# Work Order ID 99065

Item Name: 205 Bent Tube

DRAWING NO. D2580	TITLE 205 SKIDTUBE ASSEMBLY	REV. E	<b>DART AEROSPACE LTD ENGINEERING ORDER</b>	D.E.O. NO. D2580-E-1	SHEET NO. SHEET 1 OF 1	SCALE NTS
DRAWN <i>UP</i>	CHECKED <i>ASS</i>	MFG. APPR. <i>ER</i>	APPROVED <i>[Signature]</i>	DE APPR. <i>[Signature]</i>		
DATE 11.12.13	DATE 11.12.13	DATE 11.12.13	DATE 11.12.13	DATE 11.12.13	DATE 11.12.13

CHANGE ALL C'BORED WELDED CROSSBOLT SPACERS TO SWAGED SPACERS

**SECTION B-B, F-F, I-I**  
NOT TO SCALE

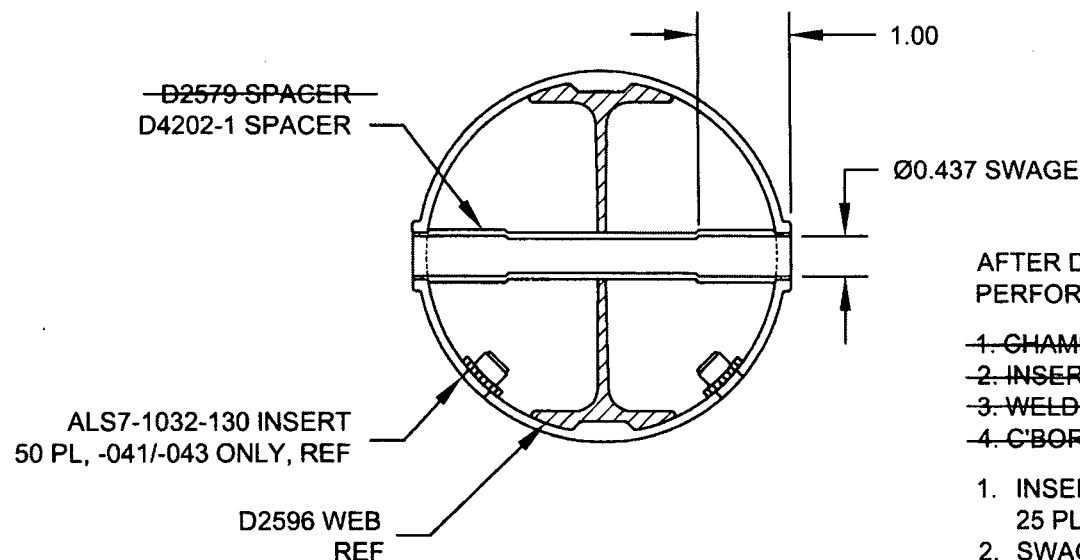
SECTION B-B, SECTION F-F, & SECTION I-I ARE AMENDED AS FOLLOWS  
FOR ALL HOLES THAT WERE ORIGINALLY C'BORED:

AFTER DRILLING AND BENDING ASSEMBLY  
PERFORM THE FOLLOWING FOR Ø0.508 HOLES ONLY:

1. CHAMFER HOLE 0.050 X 45°
2. INSERT D2579 SPACER (20 PLACES)
3. WELD INTO PLACE AND GRIND FLUSH
4. C'BORE D2579 SPACER TO Ø0.437 X 1.00 DEEP

WELD 4X D2579 SPACERS PER DWG  
IN LOCATIONS MARKED "NO C'BORE".  
REF SHEET 4 OF DWG.

1. INSERT D4202-1 SPACER, 20 PL (-041) OR 20 PL (-045) OR 25 PL (-047)
2. SWAGE TO Ø0.437 X 1.00 DEEP PER QSI 002
3. TRIM / GRIND FLUSH PER QSI 002
